DSOX92504A-03

S E R V I C E N O T E

DSOX92504A 25GHz Digitizing Oscilloscope

Front panel connector may not offer a good ground connection for probes

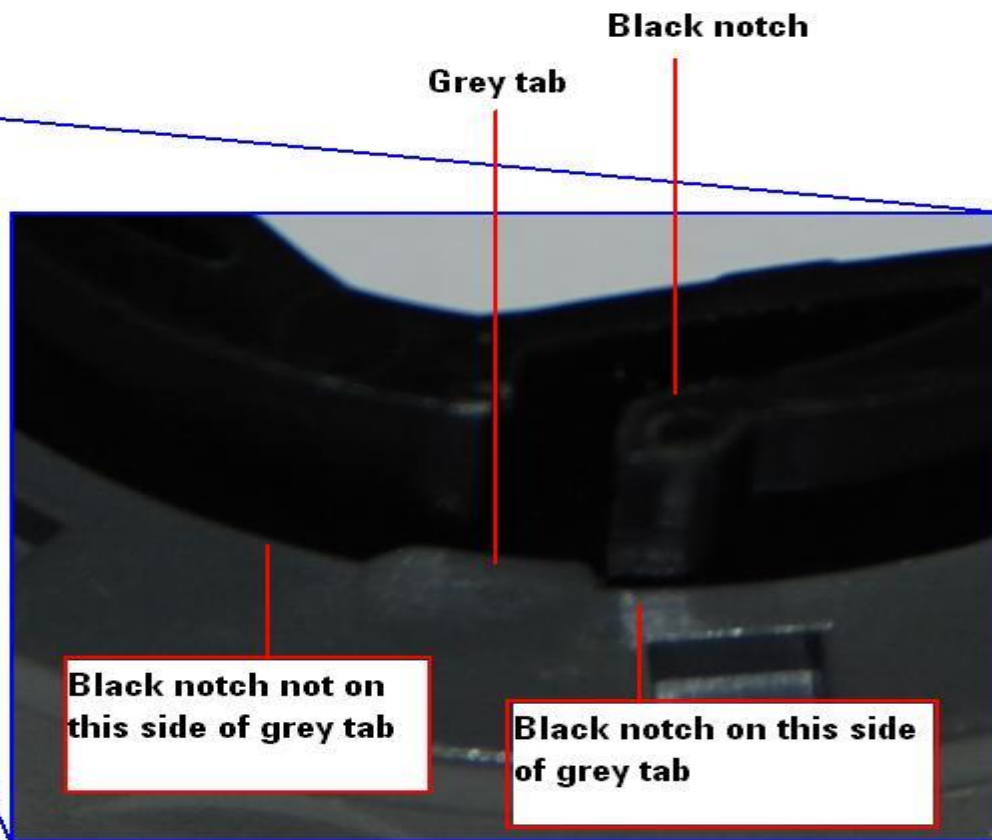
The front panel connector may not provide an adequate ground for N280XA probe amps. You may see more trace noise than you would expect.

2. Put the soft strap or string behind the gray outer clutch and carefully work it around the outer clutch.

1. Find a soft strap or something similar to remove the clutch from the front panel connector. Do not use anything metallic to pry the clutch away from the front panel. You will scratch and damage the front panel.

3. Slowly pull the strap or string to remove the clutch from the front panel.

4. Slip the spring behind the bulk head connector as illustrated below.

5. The inner clutch is always damaged when removed from the scope. Do not reuse the old inner and outer clutches. Align the notch on the inner clutch with the notch on the outer clutch as shown below. If you misalign the inner clutch, you will damage it when you press it into place. The mechanical design makes it hard to press a misaligned inner clutch into the outer clutch, but if you try hard enough, you can damage the inner clutch. Press the new inner clutch into the outer clutch. When properly aligned, it will still take a lot of finger pressure to press the inner clutch into the outer clutch.
